ADDENDUM NO. 1
TO THE CONTRACT DOCUMENTS

Date: May 25, 2015
Project No.: 497074

CROSTOWN WATER TREATMENT PLANT IMPROVEMENTS BID #960-B
FAYETTE COUNTY WATER SYSTEM
FAYETTE COUNTY, GEORGIA

AS NOTED
VERIFY SCALE
BAR IS ONE INCH ON
ORIGINAL DRAWING, 1"=1'
DATE MAY 2015
PROJ 497074
DWG 30-M-05
SHEET 49 of 73

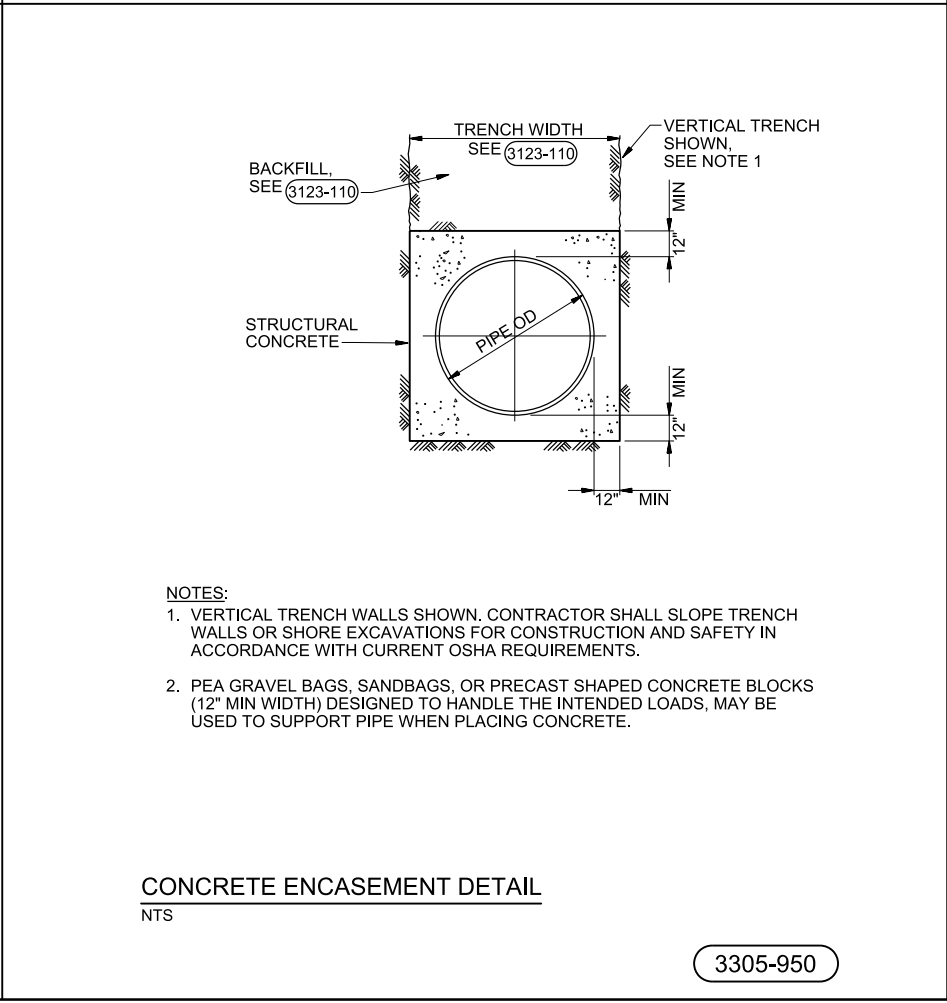
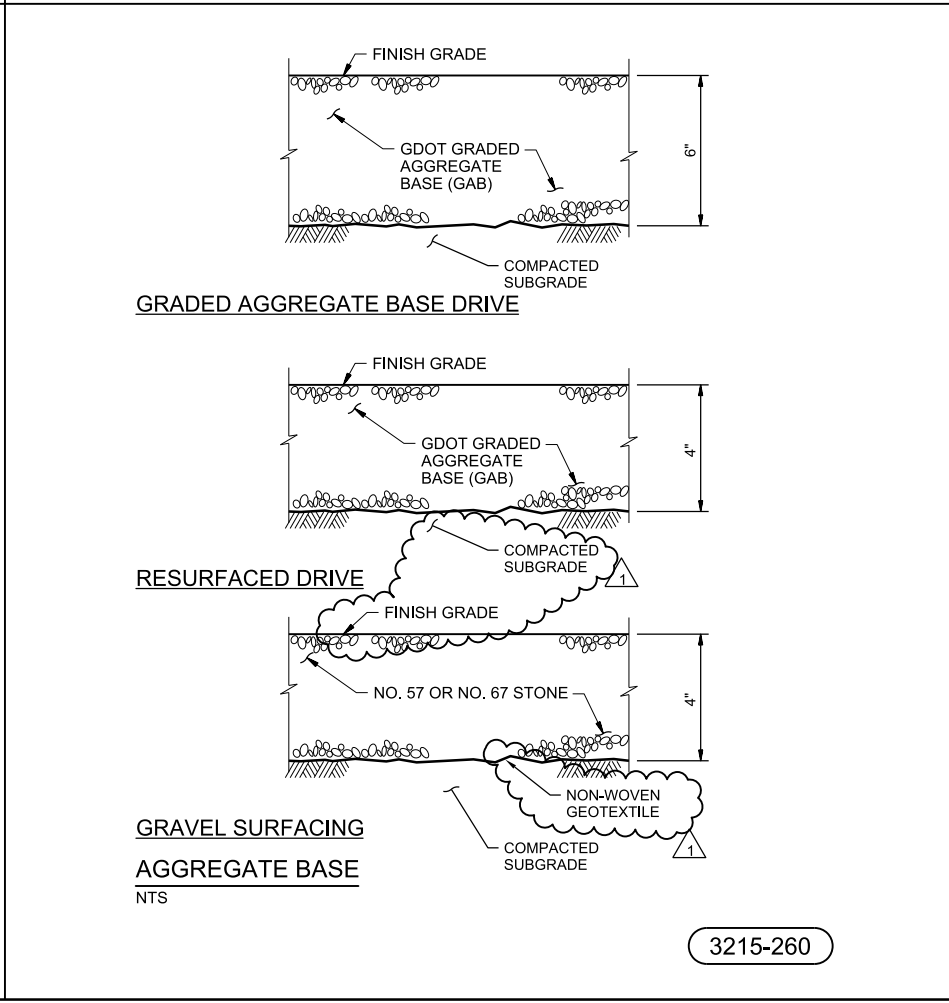
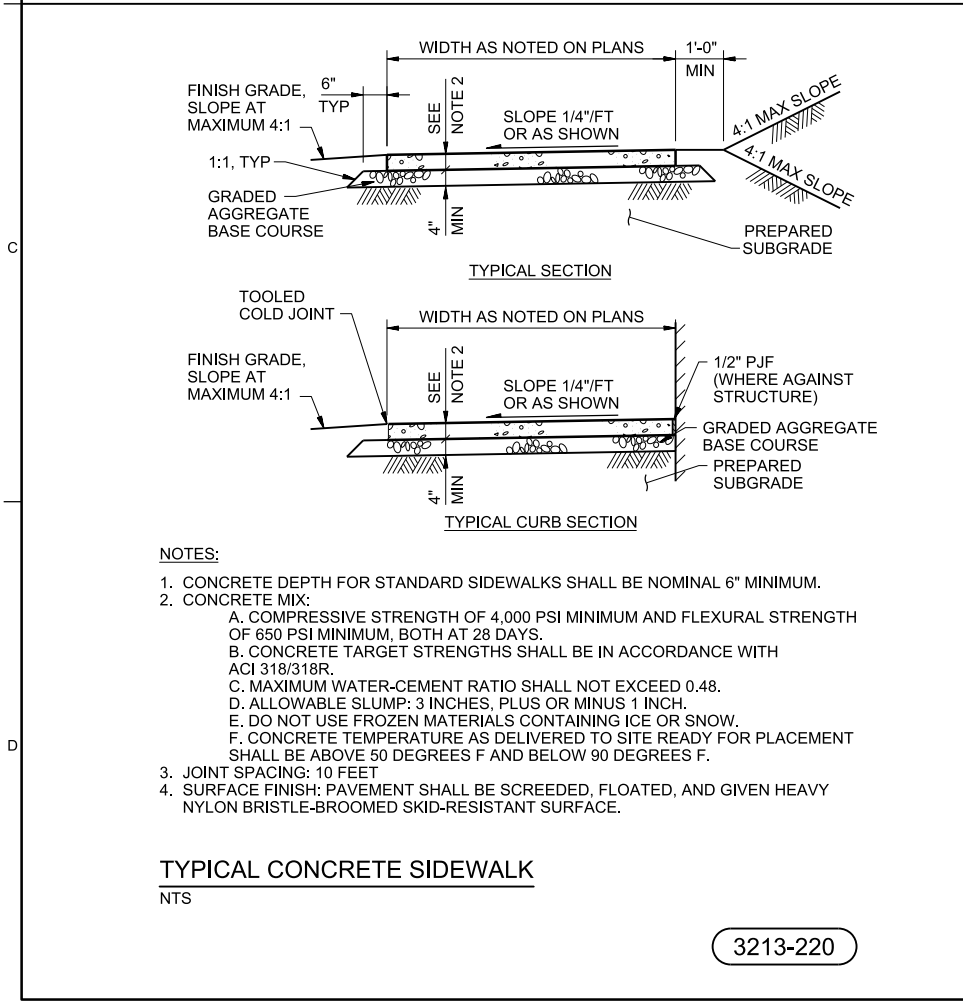
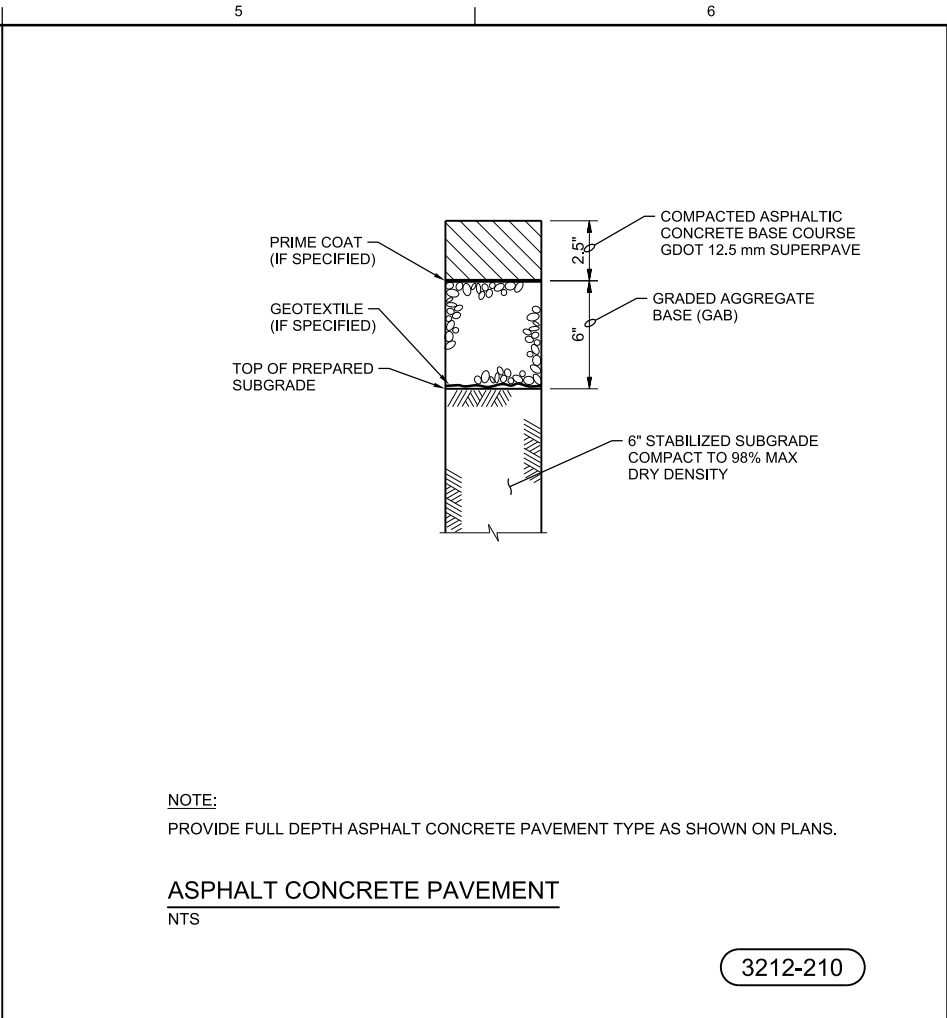
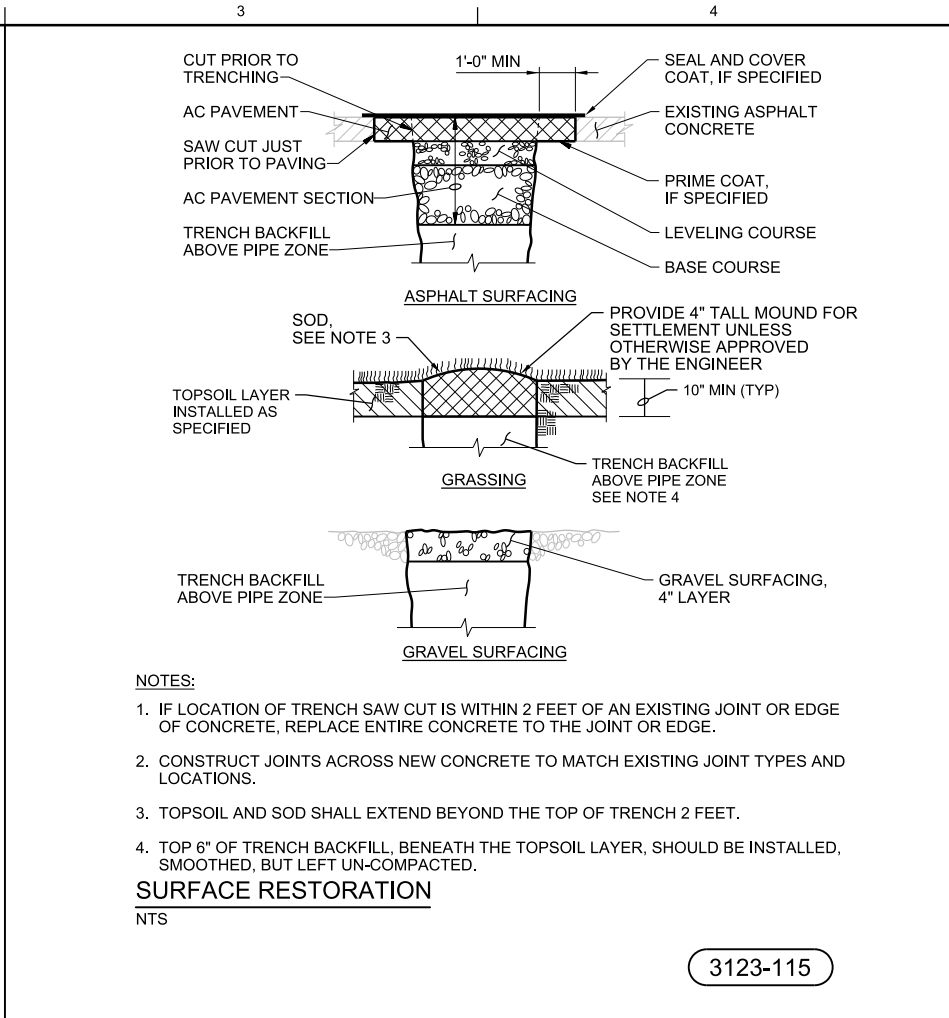
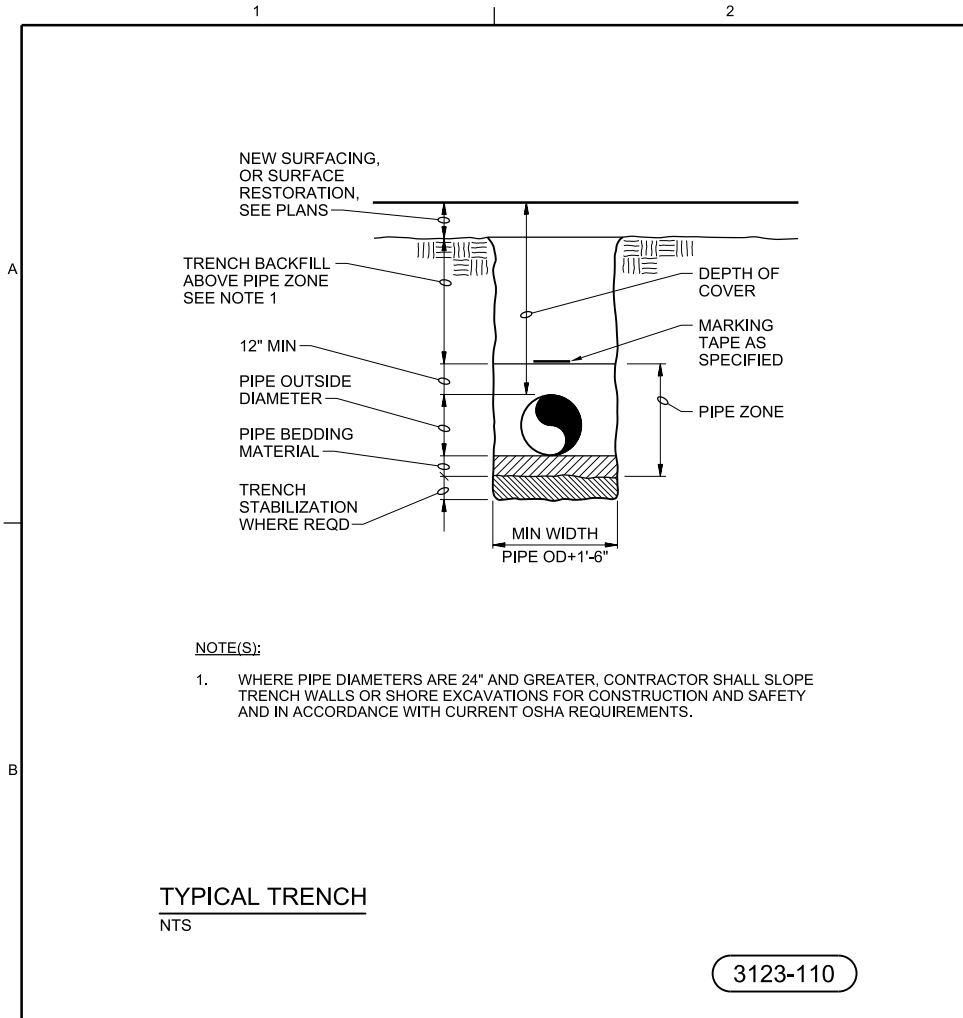
10. Drawing 30-M-05, DELETE in its entirety and REPLACE with revised attached.

0330-056

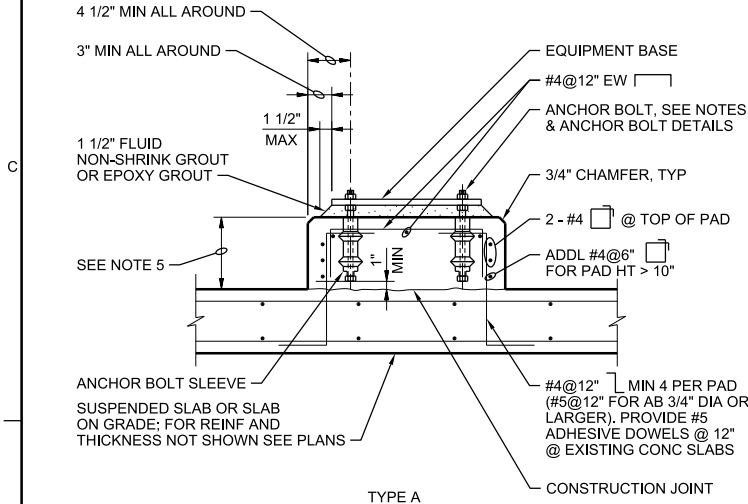
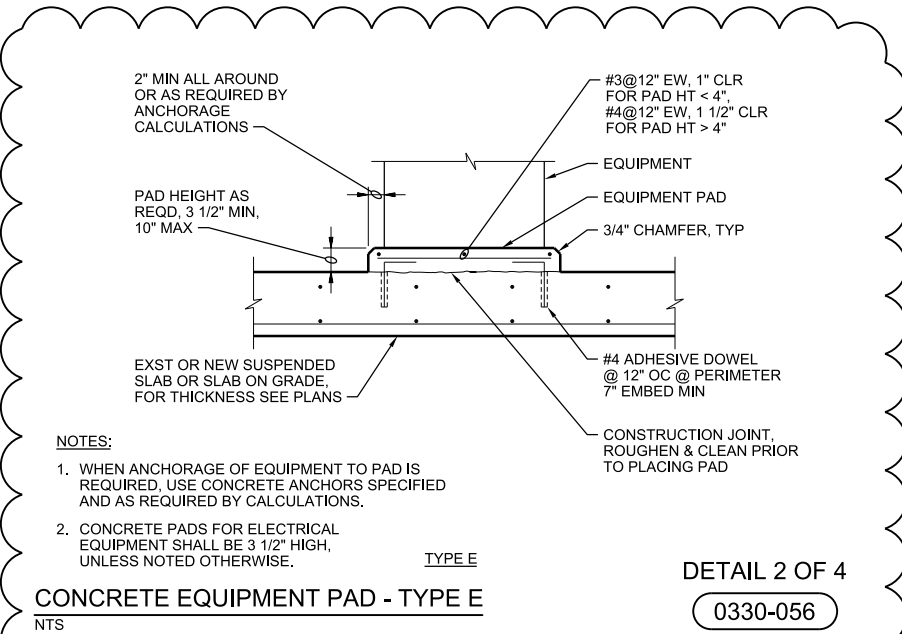
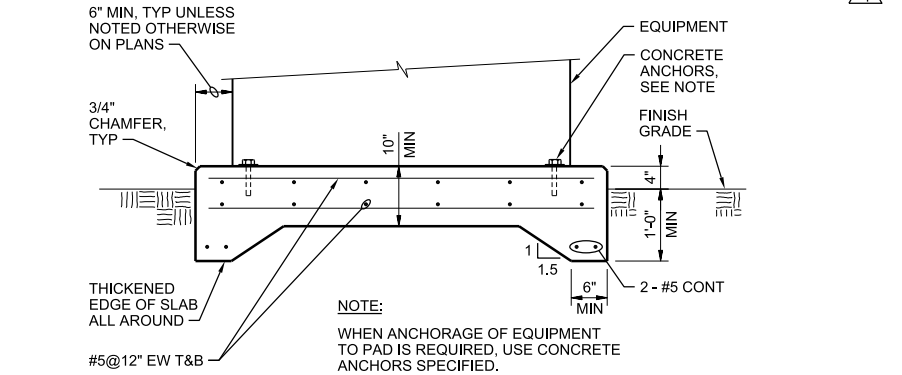
Drawing SD-02, REPLACE Detail 0330-056 with revised attached.
Drawing SD-05, REPLACE Detail 4027-640 with revised attached.
Drawing SD-06, ADD Details 0552-001 and RPZ BACKFLOW PREVENTER
ENCLOSURE DETAIL attached.

3471-810

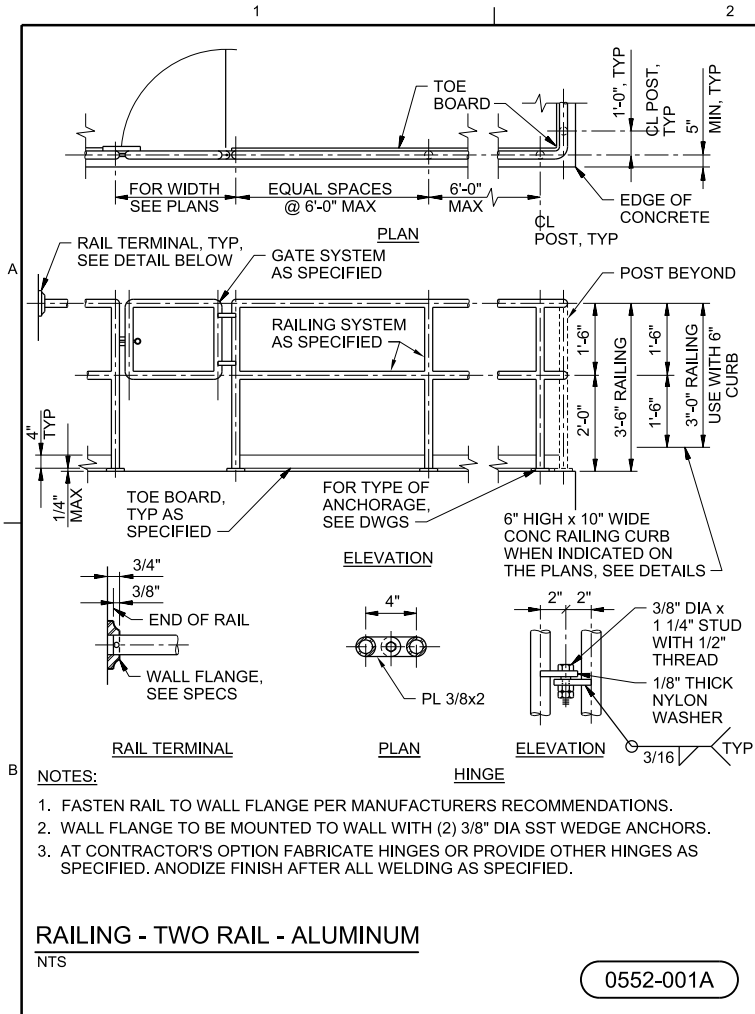
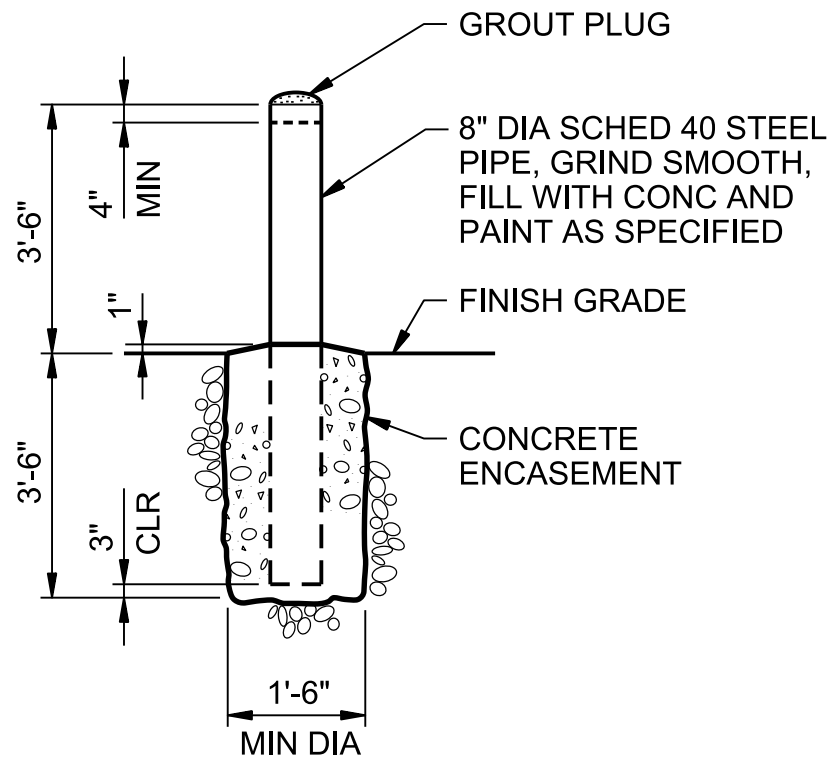
Grid location 4A, ADD two Guard Post – Exterior Detail 3471-810 in front of chemical vault (N.I.C.) that is located near existing gate.

ADD Guard Post – Exterior Detail 3471-810 attached.

3305-740

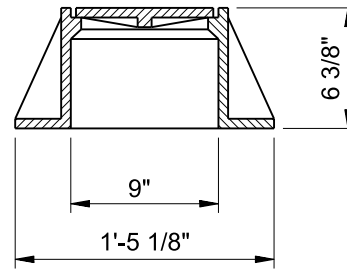
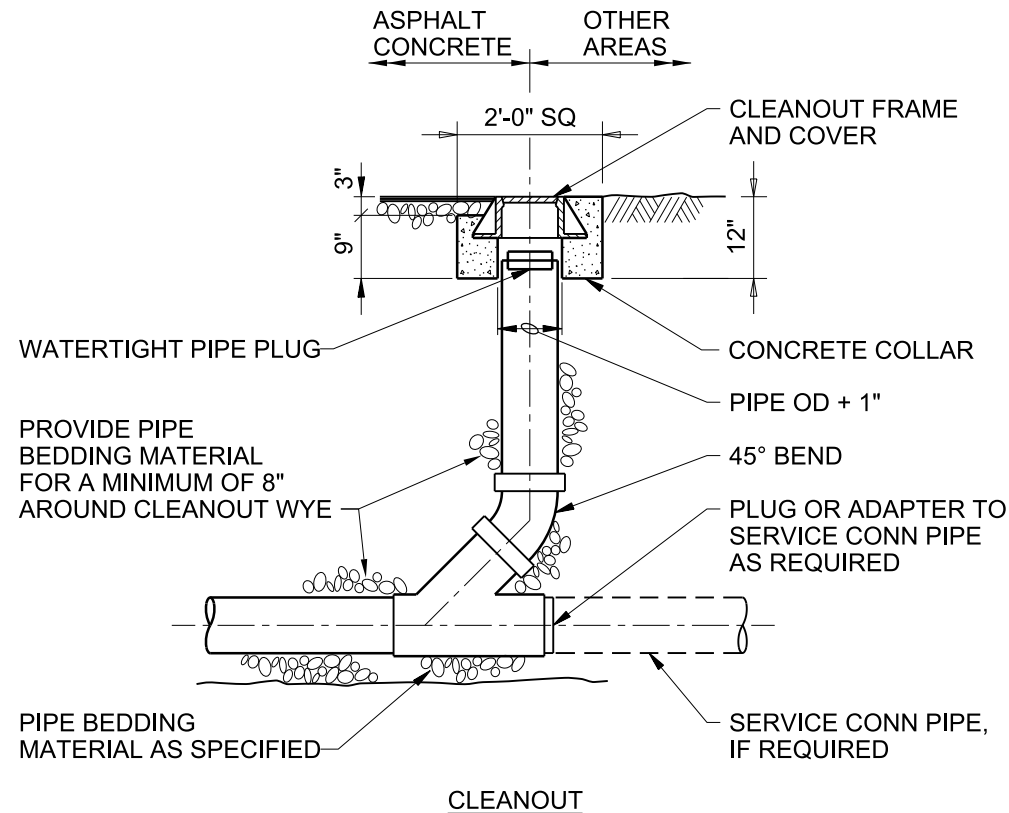
Grid location 5B, ADD Exterior Cleanout Detail 3305-740 at bend on relocated sanitary sewer drain line.

ADD Exterior Cleanout Detail 3305-740 attached.
